OPEL MANTA 2.0 E

VDT-I-OPE 019 En

Motor Vehicle Service Information

Drawing 1

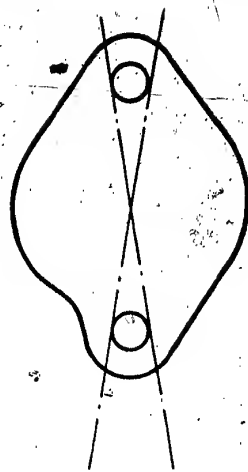
Correct the start of injection (advanced adjustment) in the starting range by fitting a modified timing-device cover with a 2 mm collar. Conversion can be carried out without removing the fuel-injection pump.

The cover (see drawing 2) can be user-fabricated as follows:

1. Remove the vacuum pump.
2. Check the start of delivery and correct, if necessary:
 - 2.0 l : start of delivery = 1.04 mm after BDC, engine TDC
 - 2.3 l : start of delivery = 0.93 mm after BDC, engine TDC
3. Exchange the original timing-device cover 1 461 074 302 (pressure side) for the modified timing-device cover KDEP 1129 (see drawing 1). Before fitting, this modified cover must be marked with your workshop designation.

OPEL SENATOR / MONZA 2.5/3.0 l
Modification to wiring harness when
replacing trip computer

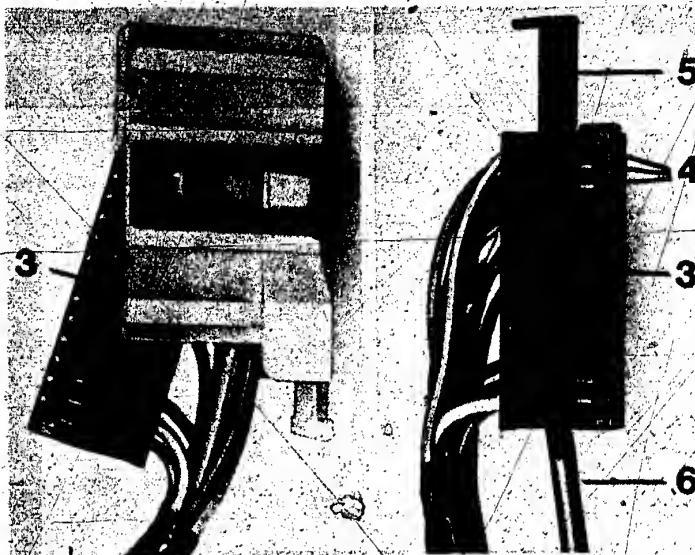
When replacing trip computers 0 263 001 000/001, ..002/003, ..006/007 ..008/009, ..010/011, ..014/015 with versions ..022/023, the original Opel wiring harness must be converted as follows:

- Cut through clamping band (2) on handle cover (1) (see picture).

Fig. 1 1 = Fuel-line-pressure damper (see Section 2)
2 = Control-pressure-reduction valve
3 = Thermo-switch

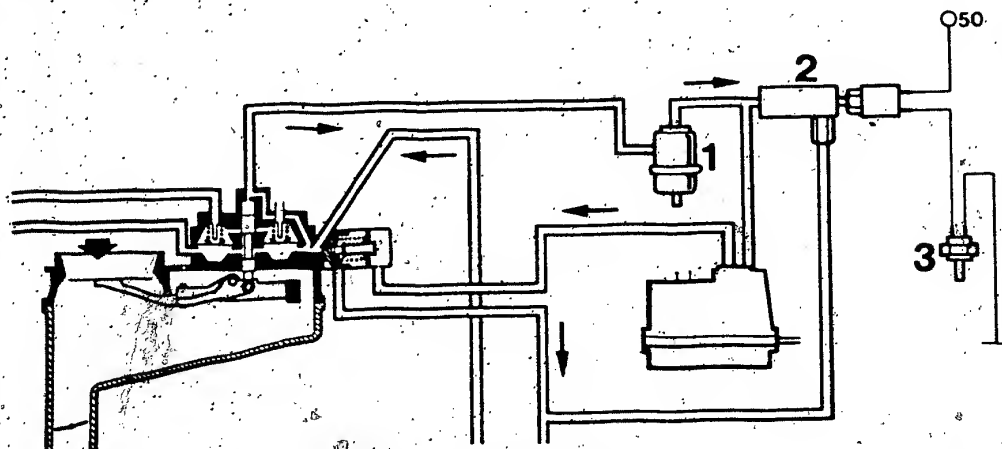
Since, after switching off the engine at normal operating temperature, it is possible for vapor bubbles to form in the fuel-injection lines, advantages can be gained from reducing the control pressure when hot-starting. The thus increased fuel delivery accelerates the process of driving the vapor bubbles out of the injection lines and therefore improves the starting ability of the engine. This reduction in control pressure is brought about by the above-mentioned control-pressure-reduction valve.

Fig. 3

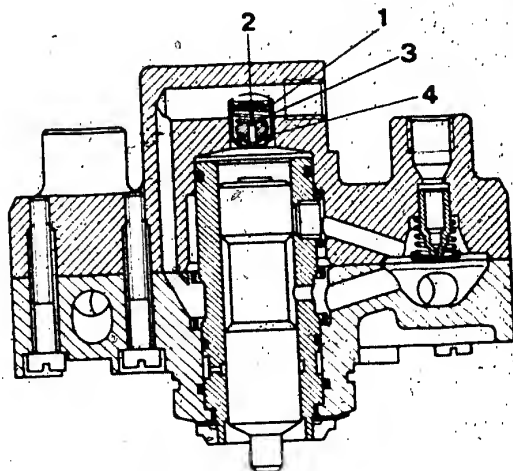
The enrichment of the air-fuel mixture necessary for acceleration is determined by the overshoot of the air-flow sensor plate and the resulting rise of the control plunger. The degree of overshoot is determined by the size of the restriction above the control plunger. In the case of rapid acceleration the valve piston in the capsule valve is lifted, thus resulting in a faster displacement of the fuel over the control plunger. This optimizes the transition response of the engine. The valve piston remains closed under slow acceleration and in all other engine operating conditions.

This modification of the fuel distributor was made without changing the part number. However, the different versions are identified by the color of the nameplate:

Fig. 4 Parts required with pressure damper

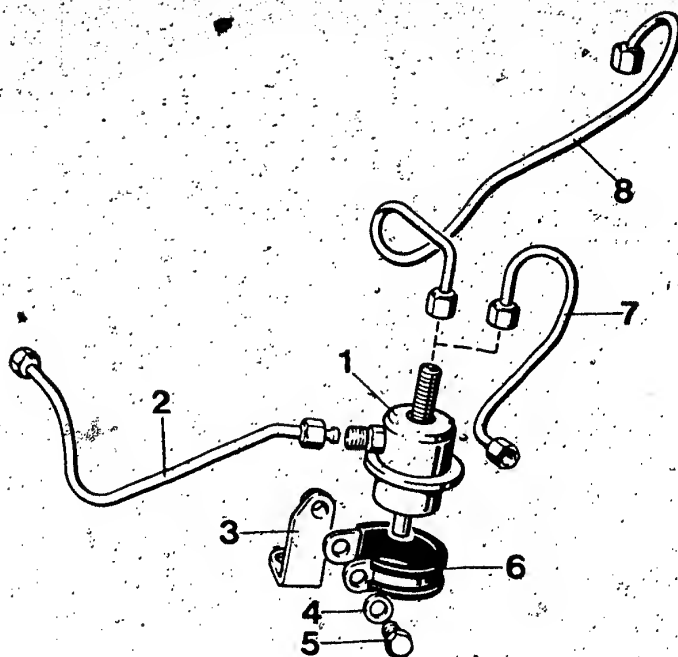
In addition to the Bosch pressure damper, various fasteners and connection lines are required for installation. These can be obtained from the Porsche agent. The choice of correct lines and the correct manner of connection depends on whether the engine is equipped with the auxiliary device for control-pressure reduction (see Section 1).

- o Remove the intake tube of cylinder 4.
- o Remove the fuel line (control-pressure line) from the fuel distributor to the warm-up regulator, or from the fuel distributor to the control-pressure-reduction valve (if fitted).

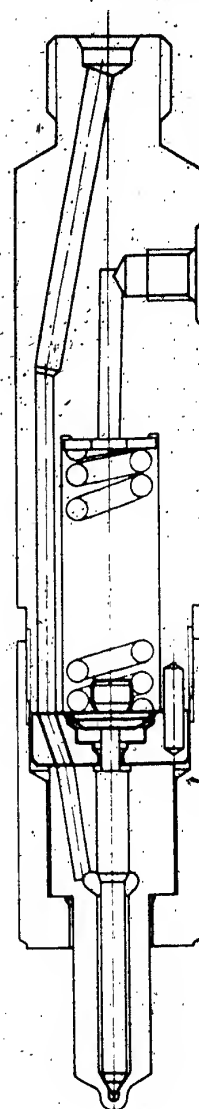
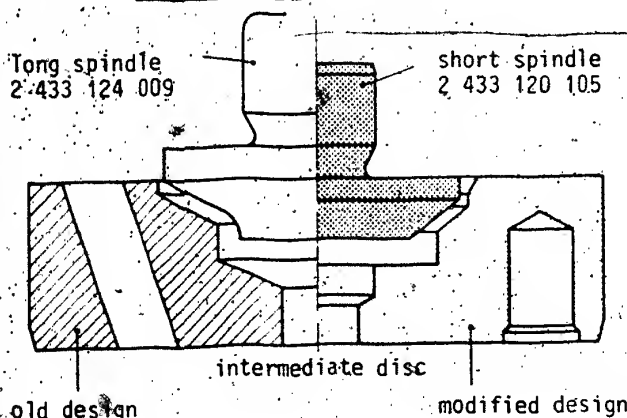
On various occasions pintle breakage occurred with
nozzle holder assemblies up to FD 824.

Starting with FD 825 this nozzle holder assembly will
be manufactured with shorter spindle 2 433 120 105
instead of 2 433 124 009 and modified intermediate
disc 2 430 136 078.

The new, short spindle 2 433 120 105 can only be used
with the modified intermediate disc.

The old, long spindle 2 433 124 009 can be used both
with old and modified intermediate disc.

The old, non-modified intermediate disc can only be
used with the long spindle 2 433 124 009.

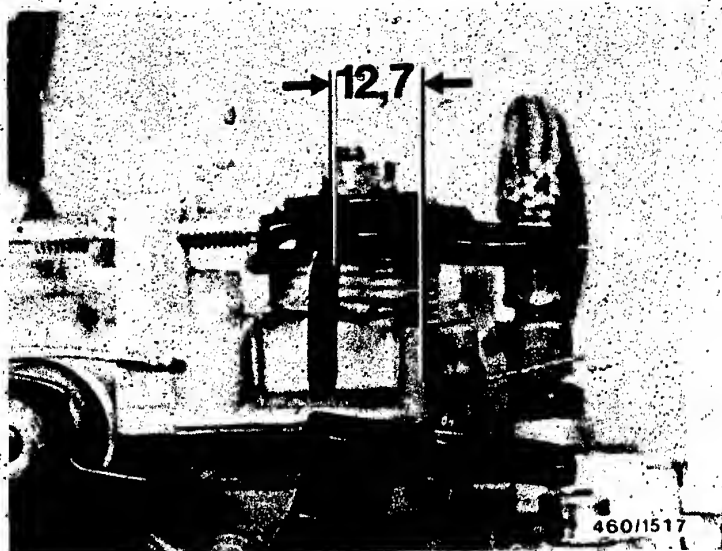
For adjusting, the control lever of the injection pump must be up against the idle-stop screw of the pump (arrow).

Correct by changing the position of the ball joint or by turning the connecting rod.

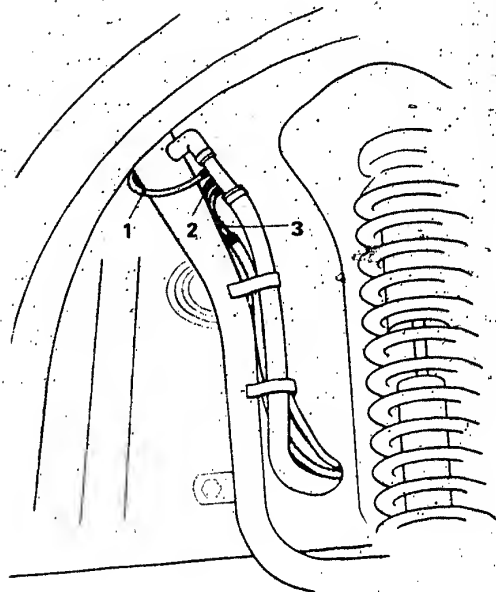
In these vehicles it can occur that the control plunger in the fuel distributor jams, due to corrosion or dirt. The result: starting troubles.

If such problems are suspected, the fuel-tank-ventilation hoses must be inspected to ensure that they are laid correctly; they must be repositioned by a VW agent if necessary. See drawing.

Fig. 1 - old design

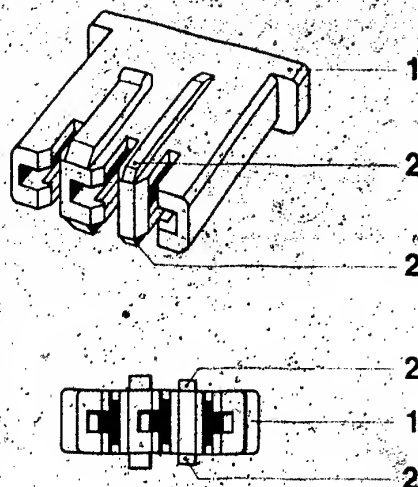
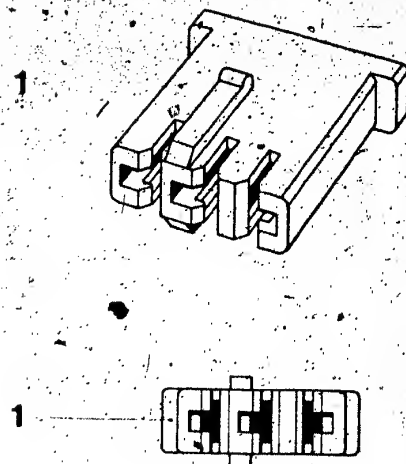
Since October 1980 modifications have been made to the ignition distributor connector and the plug housing on Volkswagen vehicles. This means that in the case of replacements the new ignition distributor (with new plug housing) can no longer be connected to the old distributor connector (vehicles with wiring harness).

Using a file, carefully remove the two long narrow guide noses on the ignition distributor connector - old design (Fig. 1).
Please note: The new distributor connector fits into both the old and the new ignition distributor plug housing.
